Technical Bulletin

Section Title: Engine
 TSB No. TS 35 12103

SUBJECT: SPECIAL COVERAGE EXTENSION FOR SPECIFIC CRACK(S) IN THE CYLINDER HEAD.

MODEL(S): GRAND VITARA (JB) WITH 2.4L ENGINE

FAILURE AREA

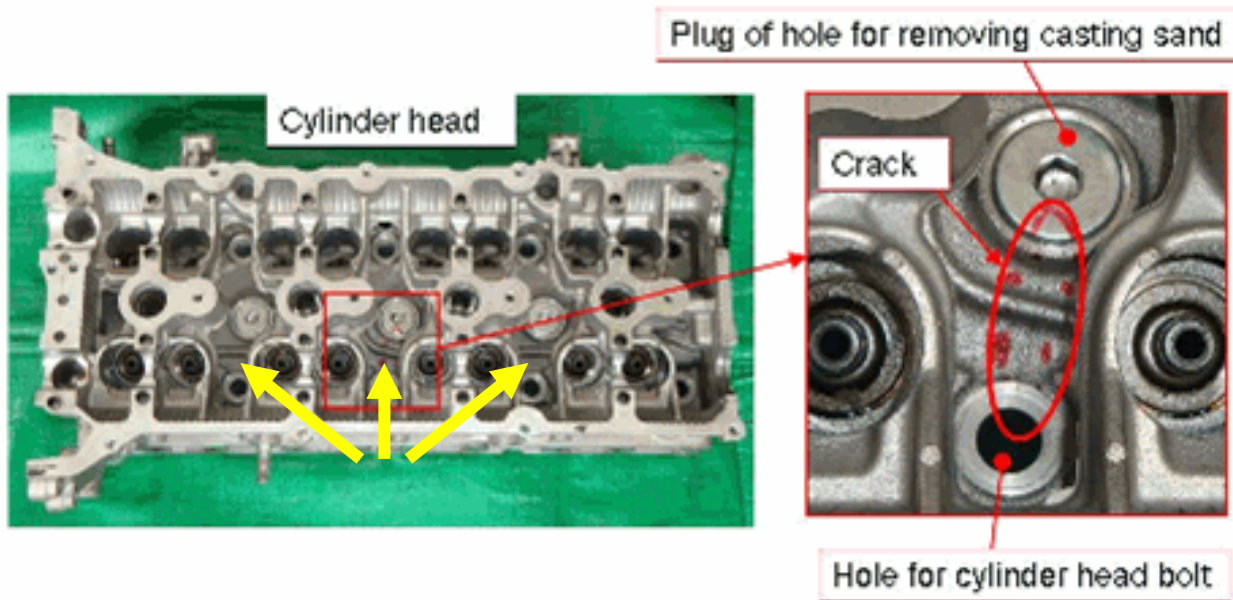
Cracks located in the 3 areas indicated by arrows may be eligible for coverage.
